BULLETIN NUMBER
42-41

3 December 2008

Top Tank Replacement for C500 & W900 with ISX; Field Campaign

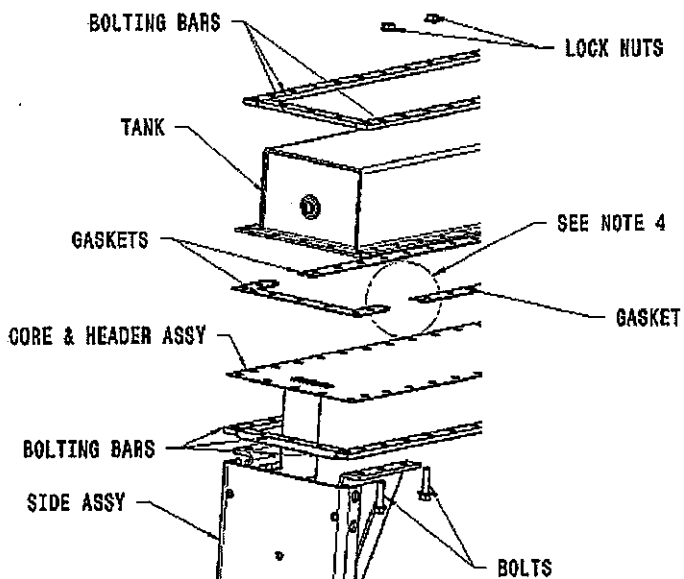
Early design top tanks on 1430 square inch radiators for 2007 emissions compliant engines can create coolant pump and/or Exhaust Gas Recirculation (EGR) cooler failures.

A vortex may form in the radiator top tank allowing air ingestion in the cooling system prior to a low coolant alarm. Air in the system can lead to cavitation within the coolant pump and possible EGR cooler failure.

1. On a cooled system, drain coolant from the radiator. Retain coolant for refill.
2. Remove and discard tank bolts, nuts and gaskets. Do not reuse hardware.
3. Thoroughly clean the gasket sealing surface.
4. Assemble gaskets in place and apply a dab of RTV (not provided in kit) to gasket joints.
5. Replace tank, bolting bars and hardware as shown. Follow OE orientation of tank bolts if different than exploded view.
6. Torque nuts 300-350 in-lb. Do not under or over torque.
7. Refill radiator with coolant, cycle the system and check for leaks.
8. Destroy and scrap take-off parts.
